Submission

In response to the Commerce Commission's
"Draft pricing review determination for Chorus'
unbundled bitstream access service"

"Draft pricing review determination for Chorus'
unbundled copper local loop service"

By
WIK-Consult GmbH
Rhöndorfer Str. 68
53604 Bad Honnef
Germany

Figure 5-1: Price variation + 100%, reaction of copper and fibre investment in the MS Excel access module, individual variation of different as-sets, result in ARC elasticity in %

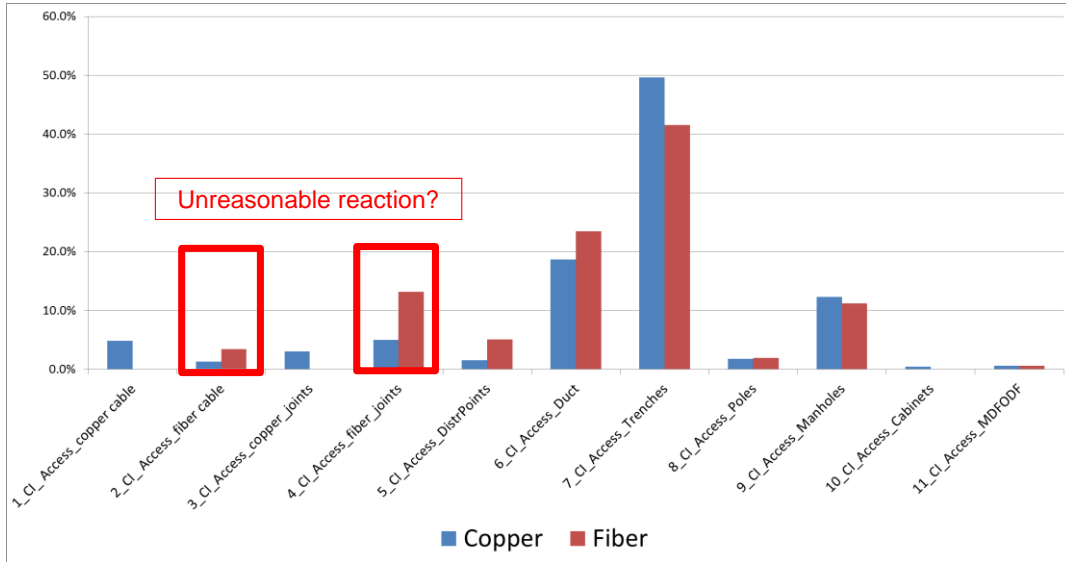
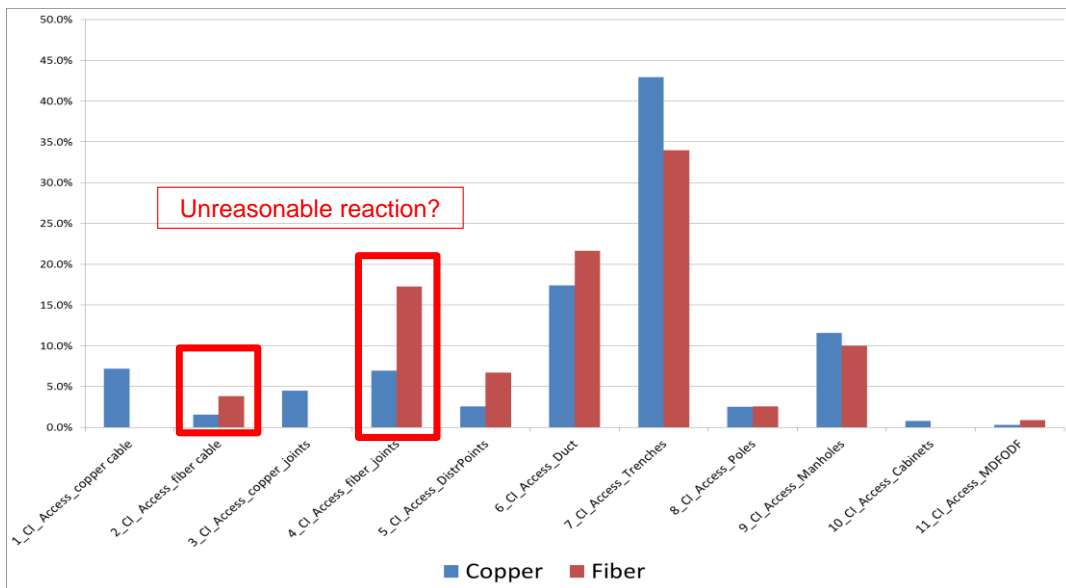
244. In varying the fibre cable prices up by 100% and down by 50% in the MS Excel access module we found that the copper investment and copper cost also reacted significantly. This also happened when varying the fibre joint cost to the same extent. The copper investment and cost did react also in a comparable manner (Figure 5-1 (investment) and Figure 5-2 (cost)). This does not seem to be reasonable. Vice versa: when varying the copper cable prices and joints to the same extent the fibre investment and cost do not react. We regard this second behavior of

the model as reasonable and would have also expected it in varying the fibre prices.

Figure 5-3: Asset lifetime variation + 100%/ - 50%, reaction of copper and fibre cost (CAPEX) in the MS Excel access module, individual variation of different assets, result in ARC elasticity in %

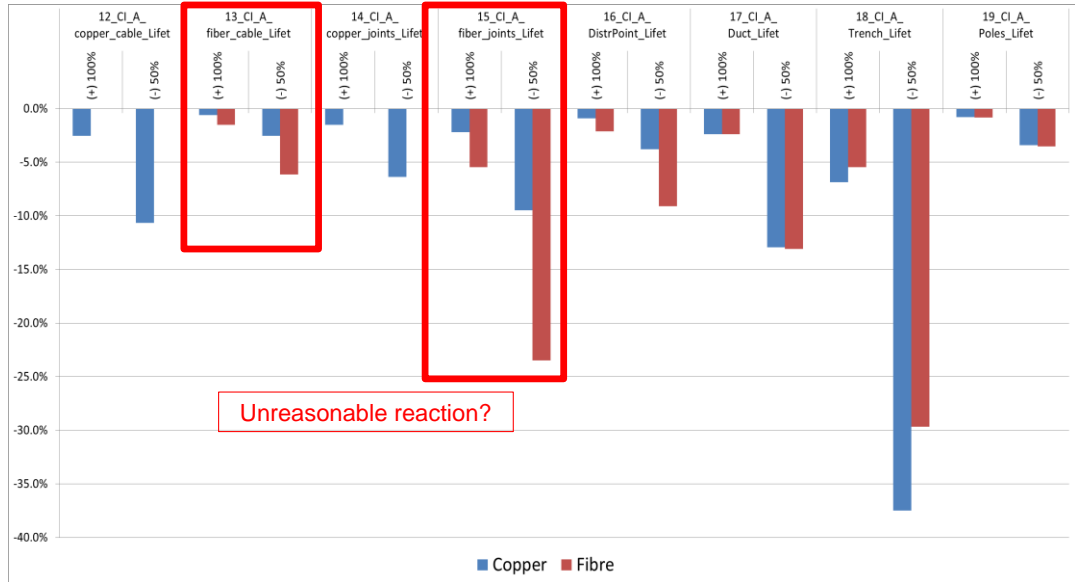
245. Varying the asset life time for fibre cables or fibre joints by +100 or -50% shows the same reactions on copper and fibre cost (Figure 5-3) as already described above when varying their prices. Once again varying the copper cable and copper joint lifetimes in the same size do not induce any fibre cost changes at all. We have expected the latter behaviour of the model. The first reaction, however, looks strange and cannot be explained by us. We believe that the model does not operate properly in this regard.

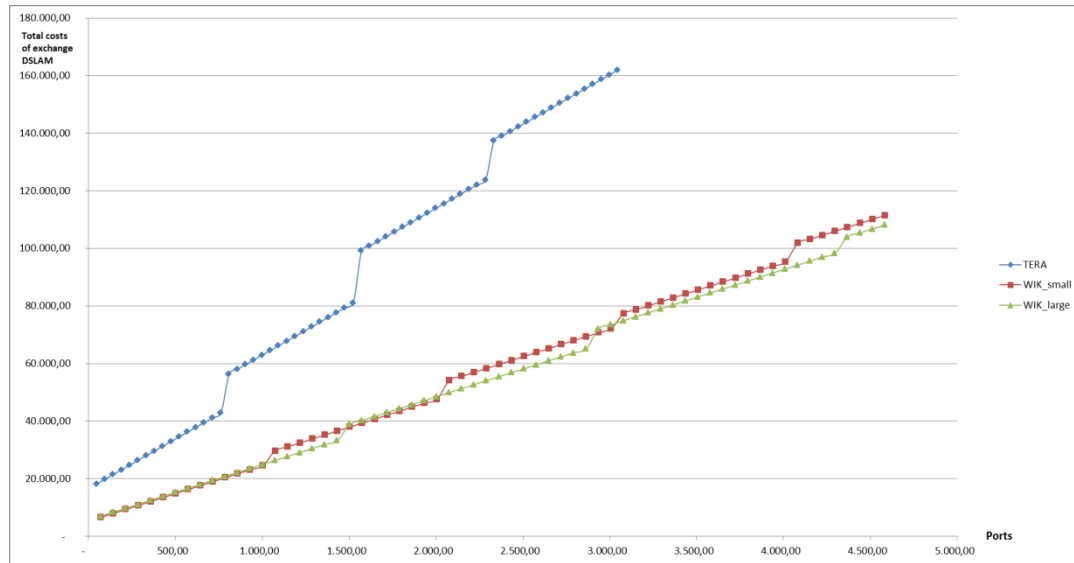
a. Cabinets

Up to about 600 incoming ports the total investment of all sizes of cabinet DSLAMs of WIK are cheaper than the DSLAM used by TERA. Regarding cabinet DSLAMs of more than 600 ports at minimum the middle sized and the largest cabinet DSLAM of WIK are cheaper than the DSLAM used by TERA. However, for every number of ports there are at minimum always two cabinet DSLAMs of WIK, which are cheaper than the single DSLAM used by TERA. Additionally the use of different cabinet DSLAM sizes allows to find the minimal cost for each cabinet location like an efficient operator would do.

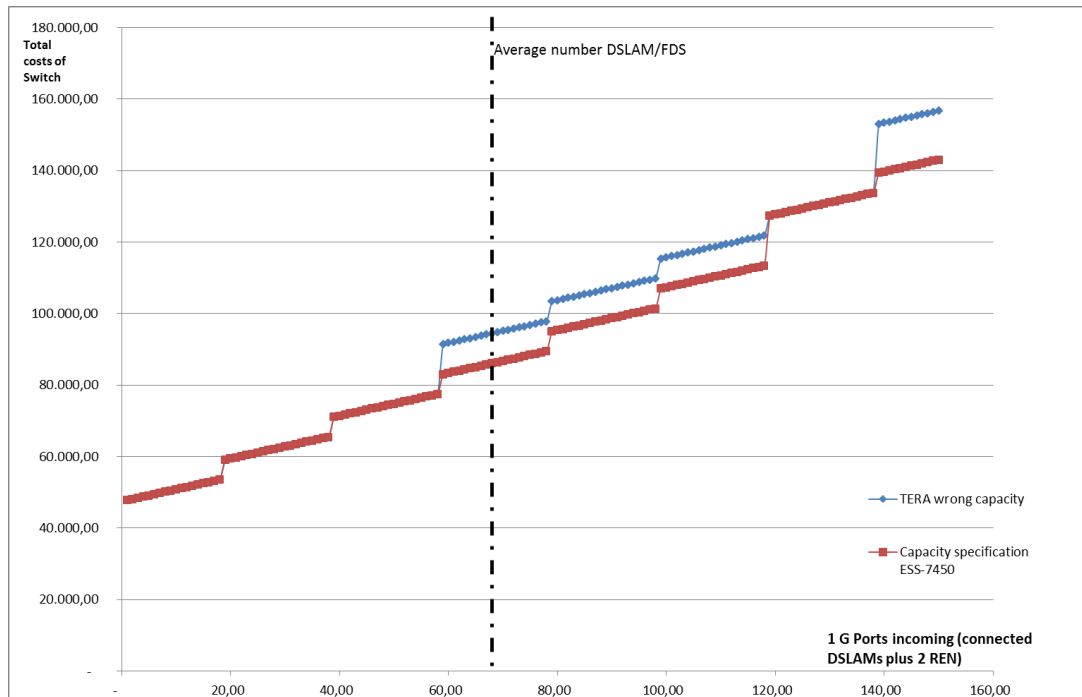
For all constellations of input ports the total investment of WIKs' exchange DSLAM's is lower than the DSLAM used by TERA. Additionally the use of different exchange DSLAM sizes of WIK allows to find the minimal cost for each exchange location like an efficient operator would do.

368. Another cost improvement could be achieved by using the stackable DSLAMs described in Section 5.4.1 ("pizza-boxes").
369. The excel file CI_ComCom-UBA Inputs v1.0.xlsx, sheet "Input – Assets" contains not only the input data for DSLAMs but also for the switches (FDS). TERA provides the data, that [...] CNZRI.

Figure 5-4: Augmented vs. individual node shortest path

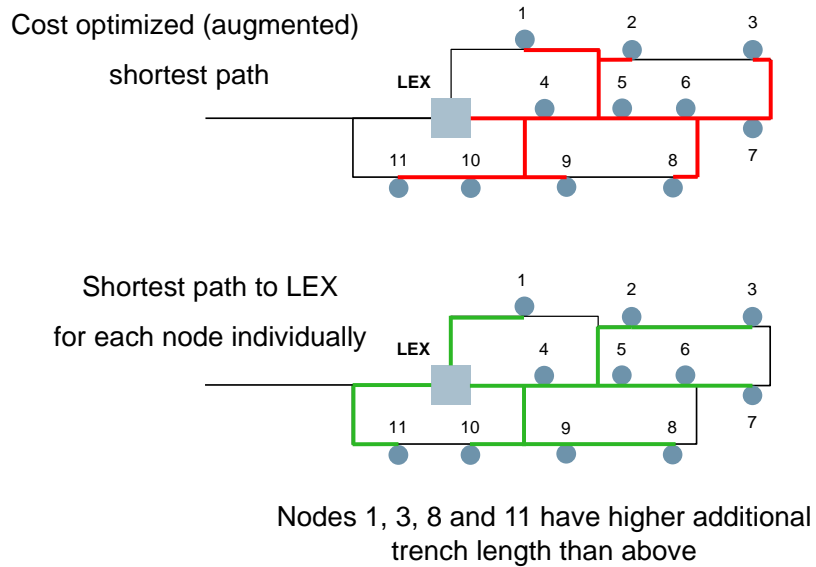
380. An algorithm which optimizes the fibre (or copper line) routes to the local exchange (LEX) individually node by node as it is described in the TERA Model Documentation (see Section 5.2.1) does typically not generate the most efficient civil engineering cost, because it does not construct a shortest trench length tree. A simple example in Figure 5-4 demonstrates the relation of both approaches. While the red graph is a shortest trench tree, the green graph is the graph resulting from all individual shortest paths of the nodes to the LEX. The incremental length for the nodes 1, 3, 8 and 11 are longer than in the green graph.

Figure 5-5: Example of uncoordinated shortest path algorithms, resulting in inefficient trenching

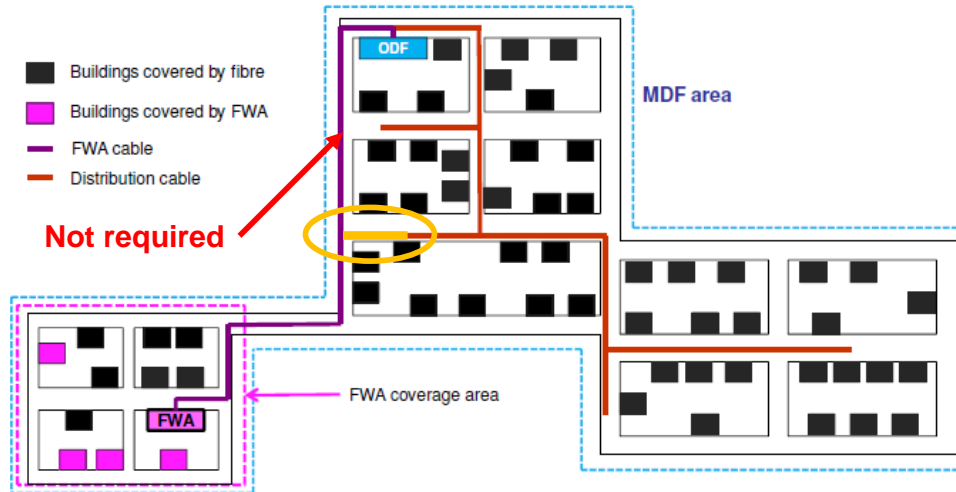
381. It is not only important to efficiently optimize the trenching towards all relevant address points but also to coordinate the efficient trenching for the FWA infrastructure and the core network links to the utmost extent. Figure 5-5 provides a negative example of mismatch of FWA and other access trenches. Here the most efficient FWA trenching would result in the short orange additional trench instead of the not required longer trench marked by an arrow.
